APPLICATION NO.	FILING DATE	FIRST NAMED INVENTOR	ATTORNEY DOCKET NO.	CONFIRMATION NO.
09/818,851	03/28/2001	Susumu Yoshiwara		9525

Office Action Summary

This is a first office action for serial number 09/818851, entitled Manufacture and use of Earthquake Resistant Construction Blocks, filed on March 28, 2001.

R. GUASTAVINO.
CONSTRUCTION OF BUILDINGS.

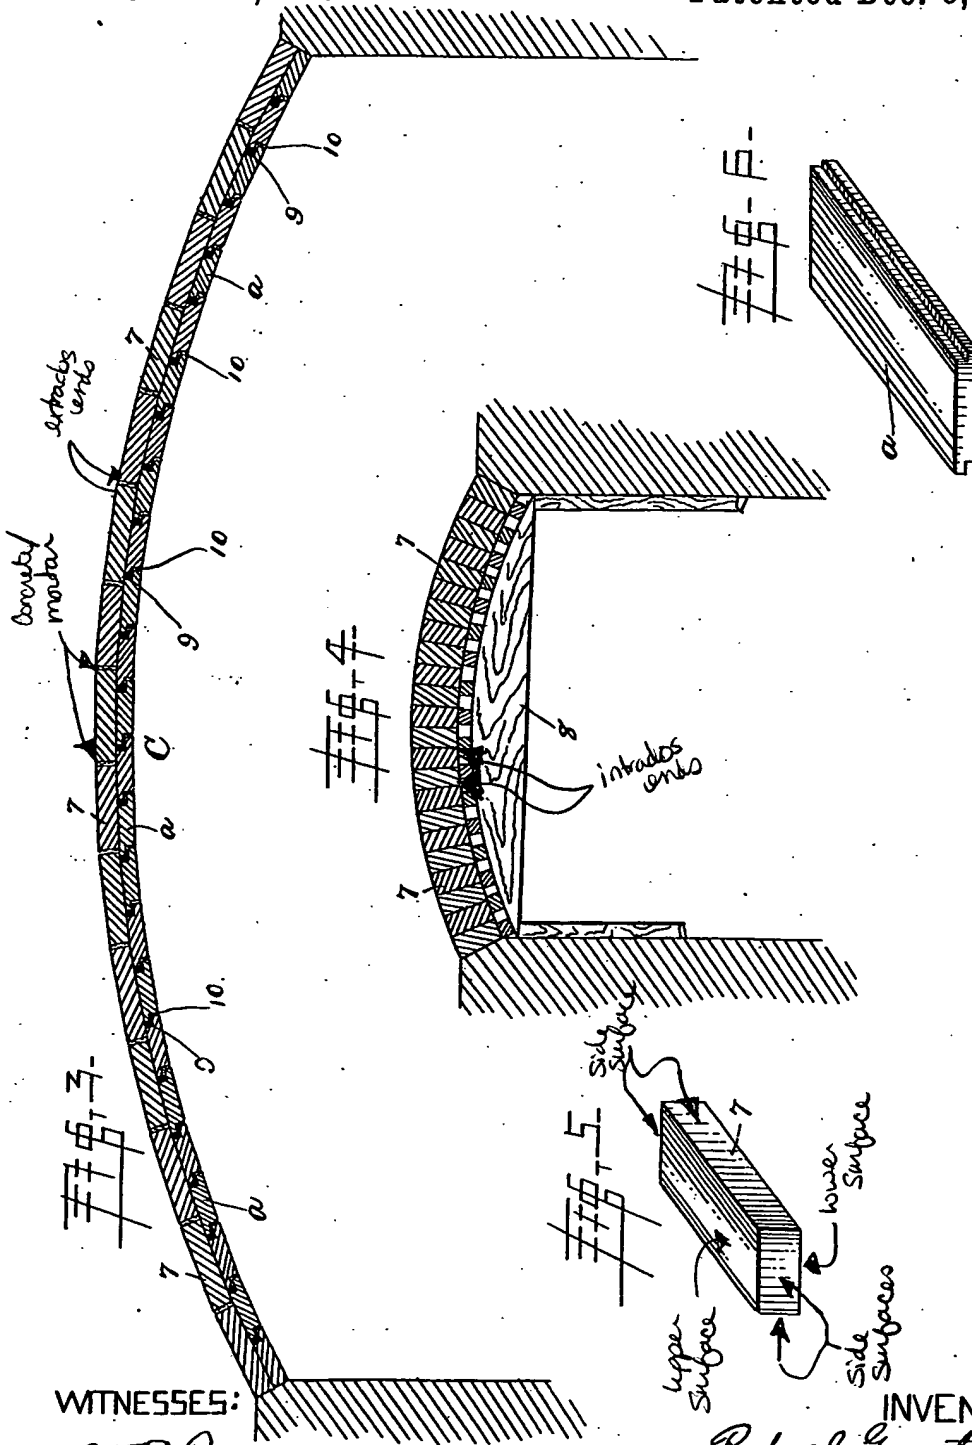
IGuastavino discloses the claimed invention a structure including a construction block (7) having an upper and lower surface and side surfaces (see attached figure 3); a plurality of construction blocks is places adjacent to one another (figure 3); the construction block is formed in the shape of a parallelepiped (figure 5), a plurality of the blocks (7) is placed side by side adjacent to one another in the shape of an arch (figure 3); and, the parallelepiped blocks placed in the form of an arch have their intrados ends abutting each other and their extrados ends spaced from each other (see attached figures 3 and 4), concrete is within the space between the blocks extrados ends (see attached figure 3); except for aggregate pieces within the block adjacent to the lower surface, the aggregate pieces being in direct contact with one another the aggregate pieces held in contact with each other by mortar, the block is in the shape of a tetrahendron, the aggregate material is coarse and fine, low quality, slag, crushed stone, concrete chips and Sirasu. Sandorff teaches that it is known in the art to provide aggregate pieces (35) within the block (30) adjacent to the lower surface (37), the aggregate pieces being in direct contact with one another (column 6, lines 35-37, by
